## PLANNING COMMISSION STAFF REPORT

**MEETING DATE:** *May 30, 2017*

**SUBJECT TITLE:** *Recommendation to City Council to Approve the Westside Refinement Plan and Accompanying implementation measures (File No. 311-17-000013-PLNG)*

### **Plum Hill Lane (12.5% Slope)**

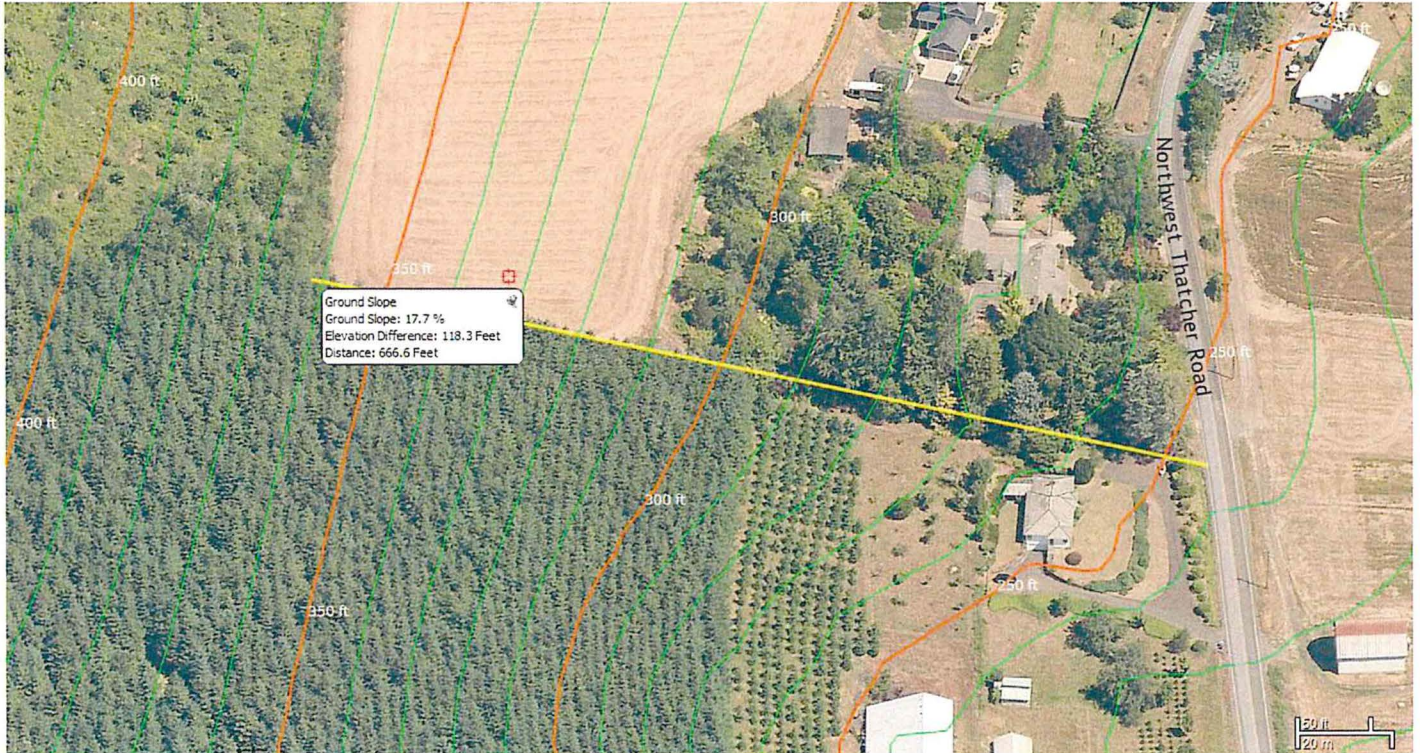
- Due to the elevation, would this major collector (Plum Hill Lane) be better situated elsewhere? Maybe further south or congruent with the access point being developed for the Green Grove Co-Housing Development?

*Staff Response: The overall grade of Plum Hill Lane is about 12.5% from Thatcher Road to the end of the street. Situating this collector elsewhere requires steeper grades and significant cut and fill or results in potential impacts to vegetative corridors and riparian areas north of David Hill Road near the stream channel. Moving the east-west street connection north to the Green Grove project increases the roadway slope to 14.9%. Further to the north slopes increase to 17.7%. Moving the collector street to the south reduces the roadway grade from 12.7% to 12.1% but the road would impact the vegetative corridor and stream. Another consideration is Thatcher Road sight distances are problematic in areas where Thatcher Road curves. Several maps showing slope for various locations north of David Hill Road and west of Thatcher Road are provided below.*
